AMENDMENT OF SOLICITATION/MODIFICATION OF CONTRACT			1. CONTRACT ID CODE	PAGE OF PAGES 1 16	
2. MODIFICATION NO.: 0003		3. EFFECTIVE DATE AUG 20, 2003	4. REQUISITION/PURCHASE REQ. NO. W81W3G-2035-7181		PROJECT NO. (If applicable)
6. ISSUED BY Department of the Army Baltimore District, Corps of Engineers Contracting Division P.O. Box 1715 Baltimore MD 21203-1715		CODE CA31	7. ADMINISTERED BY: Contracting Division, Contracts Branch CENAB-CT-C 10 S. Howard ST. Room 7000 Baltimore, MD 21203-1715		CODE E1P0100
8. NAME AND ADDRESS OF CONTRACTOR (No., street, county, State and ZIP Code)			(x)	9A. AMENDMENT OF SOLICITATION NO. DACA31-03-R-0038	
			X	9B. DATED (SEE ITEM 11) AUG 04, 2003	
				10A. MODIFICATION OF CONTRACT/ ORDER NO.	
				10B. DATED (SEE ITEM 13)	
CODE		FACILITY CODE

**UNACCOMPANIED ENLISTED PERSONNEL HOUSING (UEPH 2)
FORT DETRICK, MARYLAND**

AMENDMENT NO.0003 TO ADVERTISED RFP DACA31-03-R-0038
EFFECTIVE AUG 20, 2003

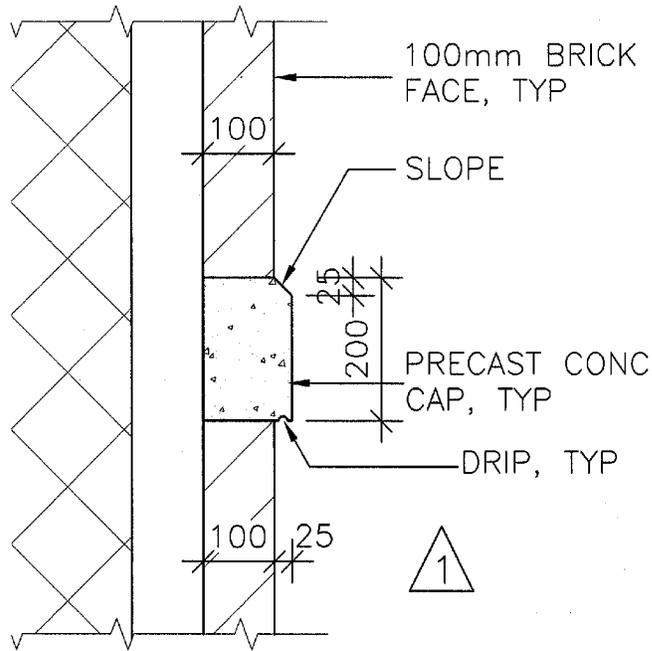
- d) Revise the bottom extent of the “1000” dimension to be at the same level as the bottom of pier shown.
- 55) Sheet S-15: Revise the values of “Bottom Elevation Of Drilled Piers @ Column Line” for Bldg. #8 in the table to read as follows:

A1	A2	A3	A4	A5	B1	B2	B3	B4	B5
97.94	97.94	93.55	93.55	97.23	97.94	97.94	93.55	93.55	97.23

C1	C2	C3	C4	C5	D1	D2	D3	D4	D5
97.9 4	97.9 4	93.5 5	93.5 5	97.2 3	97.9 4	97.9 4	93.5 5	93.5 5	96.8 4

E1	E2	E3	E4	E5	F1	F2	F3	F4	F5
97.9 4	97.9 4	93.5 5	93.5 5	96.8 4	97.9 4	97.9 4	93.5 5	93.5 5	96.8 4

A
TYPICAL DETAIL

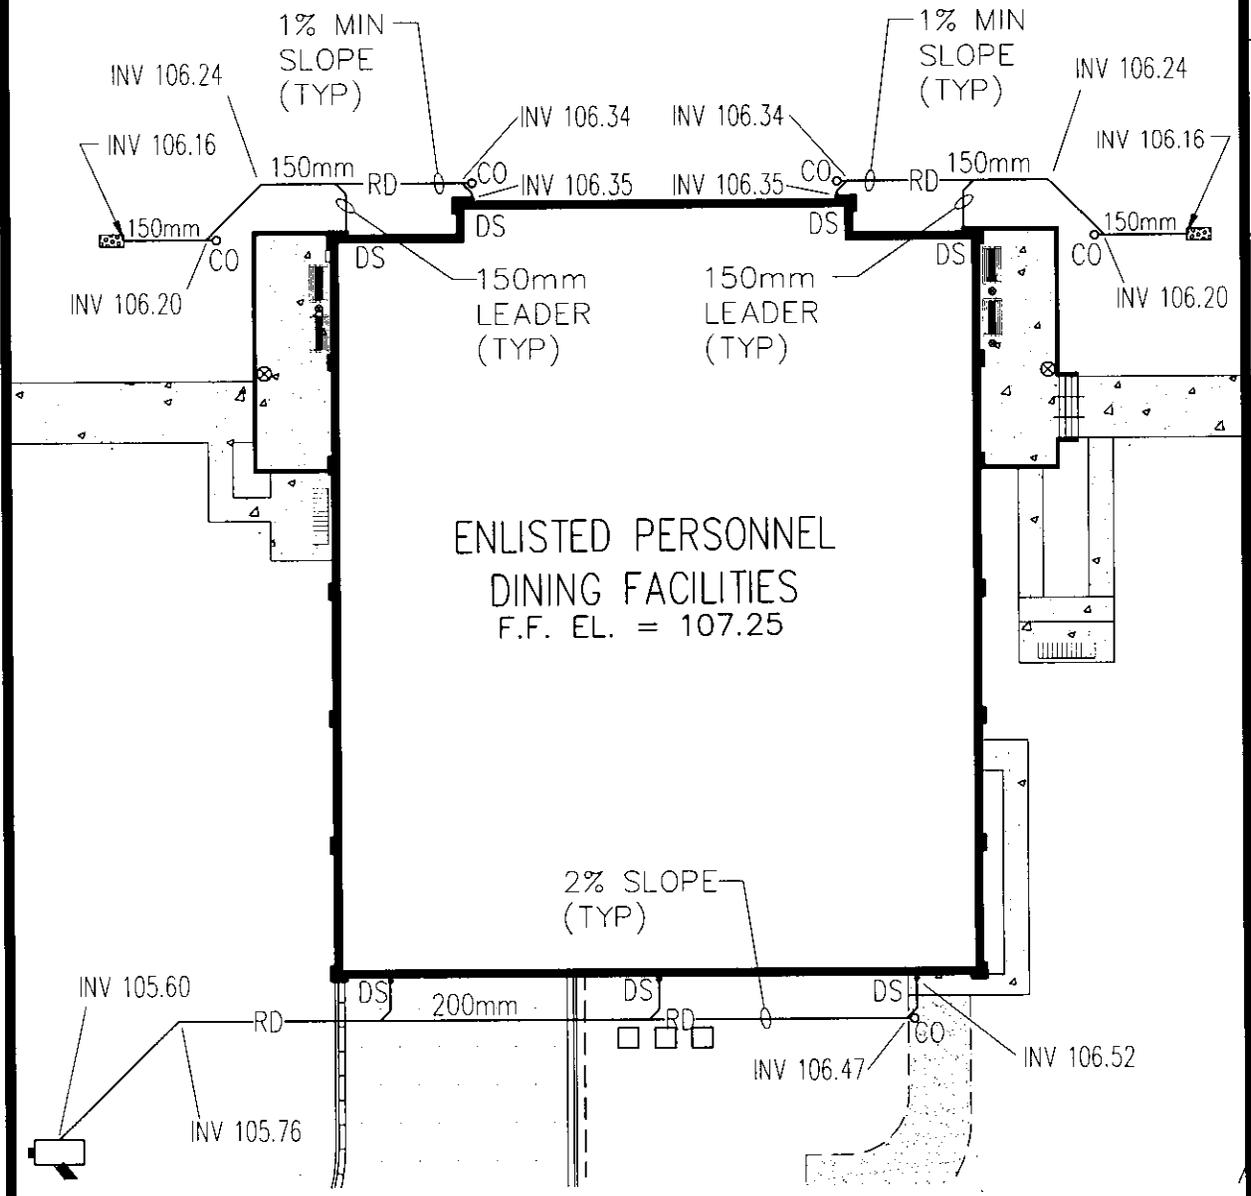
- 45) Sheet A-68:
- a) Partition Type 39: Revise note that reads “DEEP LEG TRACK....A-XX” to read “DEEP LEG TRACK....DET. A, SHT. A-68”.
 - b) Add the attached Sketch SK-A-2 dated 8/20/03.

SKETCH-C1
20 AUG 03

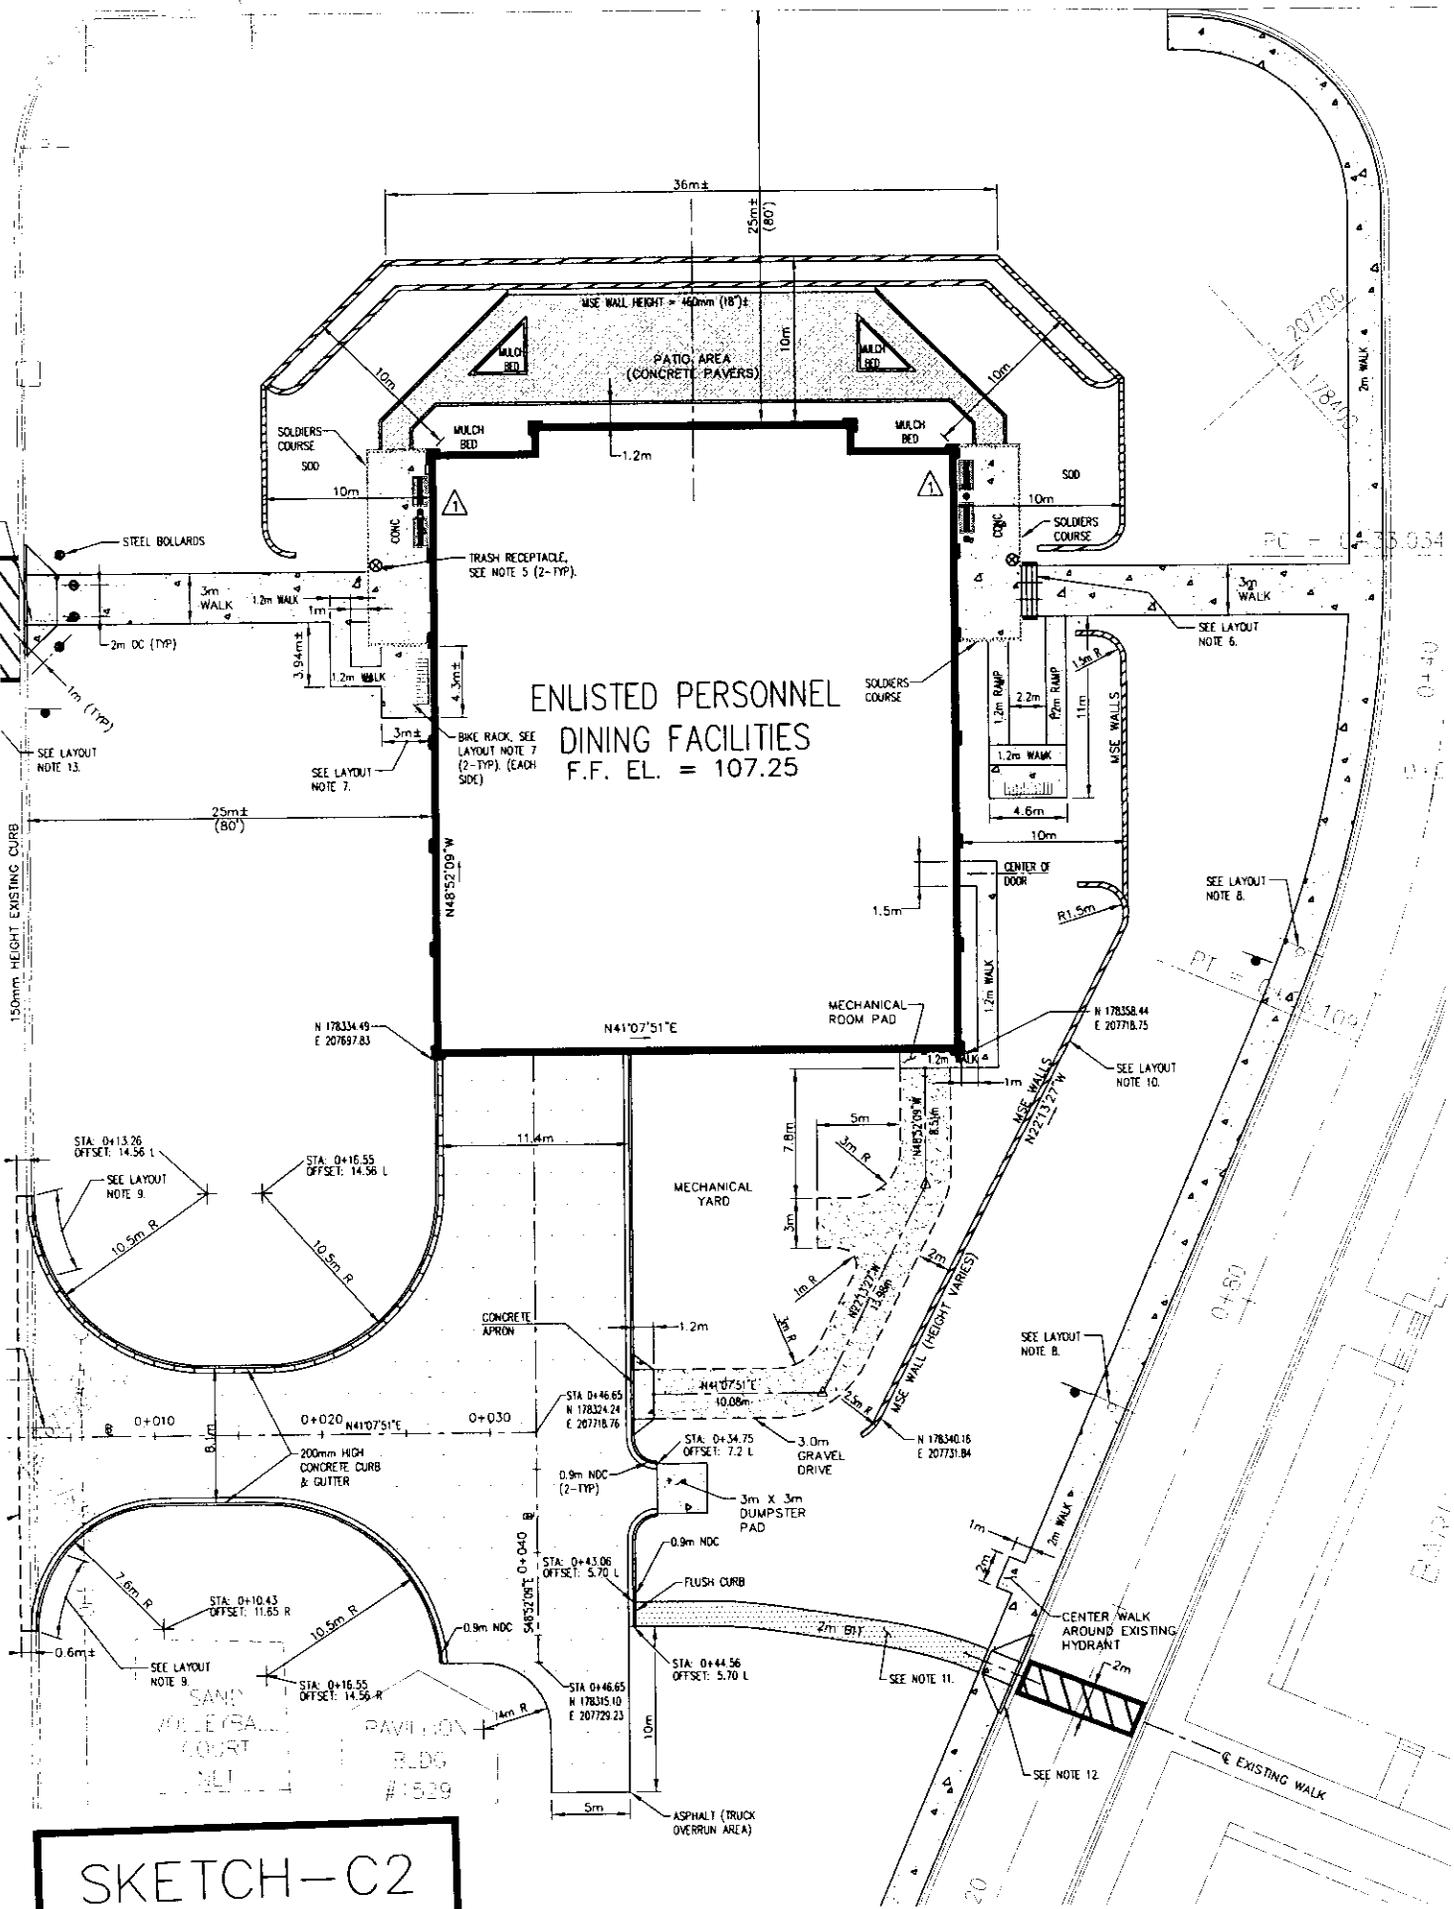
- a) Add note #1 as shown on Sketch C-1, dated Aug 20, 2003
- b) Revise this sheet in accordance with the attached Sketches C-2 and C-3 dated 20 Aug 2003.

NOTE: ALL ROOF DOWN SPOUTS SHALL HAVE SQUARE CAST IRON BOOTS 100mm X 150mm WITH THE LENGTH TO VARY DEPENDING ON THE BUILDING ELEVATIONS. THE BOOTS SHALL BE NEENAH TYPE R-4929-O9 AND R-4929-O11 OR AN APPROVED EQUAL. BOOTS SHALL BE INSTALLED IN ACCORDANCE TO THE MANUFACTURERS RECOMMENDATIONS.

SKETCH SK-MP-1

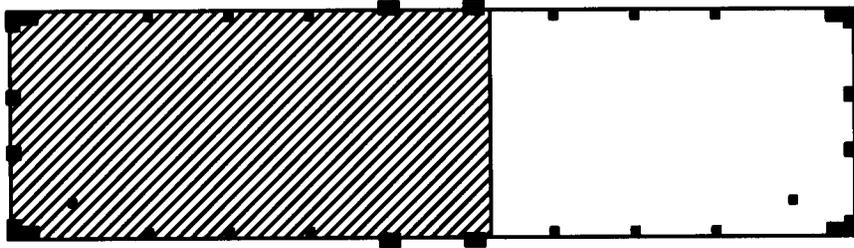
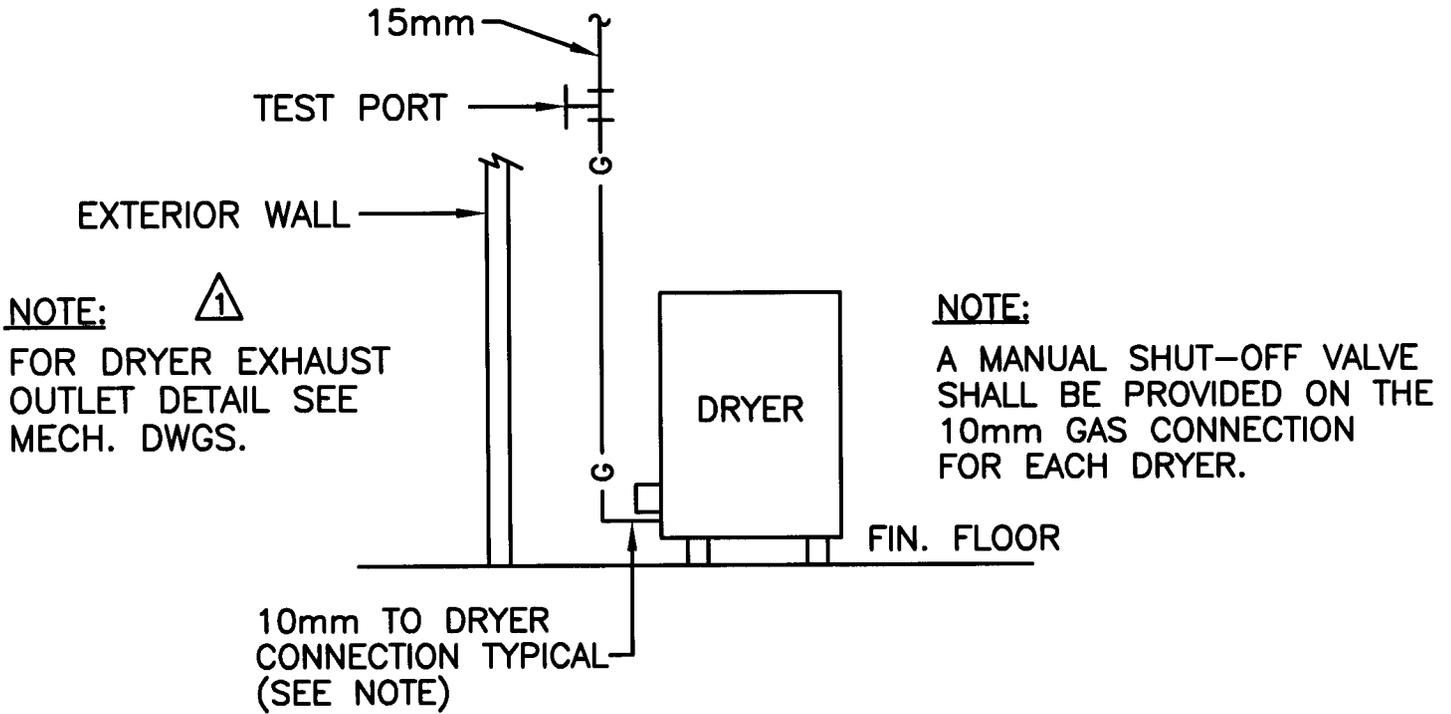
- 56) Sheet S-31: Section B – Revise “Top of Rock” to read “Top of Rock Socket”.
- 57) Sheets T-01: Delete this sheet in its entirety as originally issued and substitute the attached like-numbered sheets, dated Aug 20, 2003.
- 58) Sheet P-14: Revise this sheet in accordance with the attached Sketch SK-MP-1, dated 8/20/2003.
- 59) Sheet P-15: Revise this sheet in accordance with the attached Sketch SK-MP-2, dated 8/20/2003.
- 60) Sheet P-19: Revise this sheet in accordance with the attached Sketch SK-MP-3, dated 8/20/2003.
- 61) Sheet P-20: Revise this sheet in accordance with the attached Sketch SK-MP-4, dated 8/20/2003.
- 62) Sheet P-23: Revise this sheet in accordance with the attached Sketches SK-MP-5, SK-MP-6 and SK-MP-7 dated 8/20/2003.
